MANDATORY SERVICE BULLETIN

NO. MSB 42NG-005/1

Exchange of charged air tubing between turbo charger and intercooler.

WI-MSB 42NG-005

Picture 1

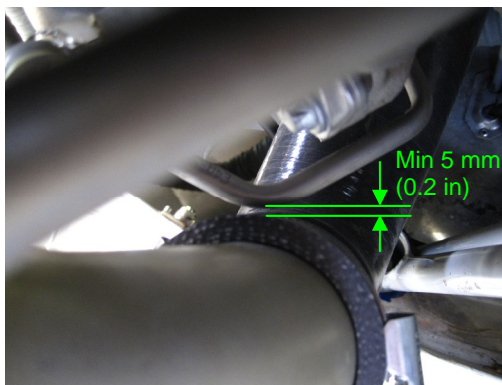
1	Remove the upper cowling on LH and RH engine acc. to AMM Section 71-10.
2	<p>Remove charged air tubing between turbo charger and intercooler (two hoses and an aluminium tube).</p> <p>Note: Let the engine cool down before working on the charged air system.</p> <p>Warning: Contact with a hot engine can cause injury to personnel.</p> <p>Note: Perform items 2 through 9 on LH and RH engine.</p>
3	Remove the Turbo Discharge Connector.
4	Install O-Ring on Turbo Connector Assy.
5	<p>Install the Turbo Connector Assy D64-8122-20-00.</p> <p>Note: Do not tighten the V-Clamp</p>
6	<p>Install Charged Air Hose D64-8126-00-04_3 on the Turbo Connector Assy D64-8122-20-00 and the Intercooler (overlap length min. 45 mm / 1.8 in) acc. to picture 1 with 2 hose clamps TORRO_60-80_12_W1 (refer to drawing 1 and 2) on each end (tightening torque 5 Nm / 3.7 lb ft). Tighten the V-Clamp at the turbo charger with 5 Nm / 3.7 lb ft.</p> <p>Note: Make sure both hose clamps sit on the tube under the hose.</p>

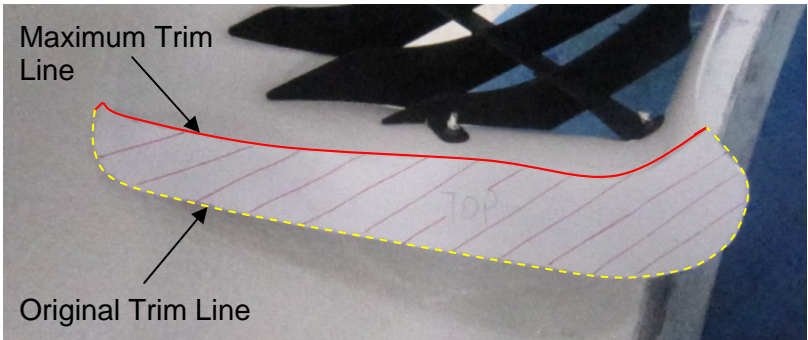
Drawing 2
7	<p>Check clearance between charged air hose and cowling outlet duct. If clearance is below a minimum of 15 mm, grind off from edge of cowling outlet duct.</p> <p>Print the template which is attached to this WI with the size indicated on the template. Position it i.a.w. the picture below. Mark the maximum trim line on the cowling.</p>  <p>Trim the cowling to the maximum trim line.</p> <p>Paint cutting edge with 2 layers of fire protective paint and 2 layers of clear coat. (AMM Section 51)</p> <p>Note: If the cowlings are already trimmed to the maximum trim line, the cowlings need not to be trimmed again.</p>
8	Clean working area and check for foreign objects.
9	Perform functional check of altered, repaired and new parts.
10	Install the upper cowling on LH and RH engine acc. to AMM Section 71-10.
11	Test all systems in working area for function.
12	Make necessary entries into aircraft logs.
